PRODUCT CHANGE NOTIFICATION (PCN)

AMJS1010-0200-BKB-26 MODULAR CABLE

CHANGE NOTIFICATION: PCN 20220425_AMJS1010-0200-BKB-26

DESCRIPTION OF CHANGES: CHANGE OF DATA SHEET
CHANGE OF DATA SHEET
New Draw.-No. ASS_7943_CArev02

Appearance

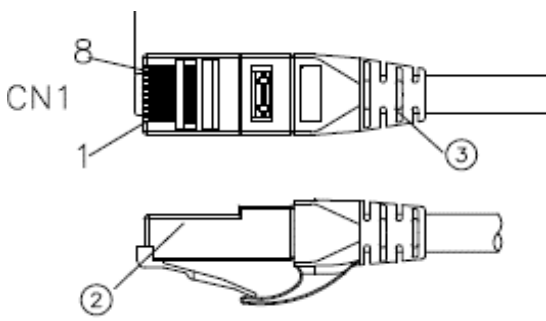
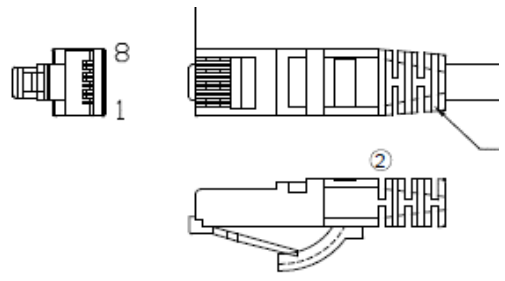
REASON FOR CHANGE: CHANGE OF PRODUCT LOCATION
CHANGE OF PRODUCT LOCATION

③	Molding	LSOH PVC 45P Color: see order code	NA	KG
②	CONNECTOR	RJ45 8P8C two fork 3u" gold plated with metal shield	2	PCS
①	CABLE	CAT6a S/FTP (26AWG*1PR+A)*4+B+LSOH OD=5.8±0.3MM Color: see order code	NA	MM
NO:	NAME	DESCRIPTION	Q'TY	UNIT

④	AL-FOIL	Double-sided conductive aluminum foil ②	2	PCS
③	Molding	LSOH 65P Color: see order code ②	NA	KG
②	CONNECTOR	RJ45 8P8C two fork 3u" gold plated with metal shield	2	PCS
①	CABLE	CAT6a S/FTP (26AWG*1PR+A)*4+B(AM)+LSOH OD=5.8±0.3MM Color: see order code ②	NA	MM
NO:	NAME	DESCRIPTION	Q'TY	UNIT
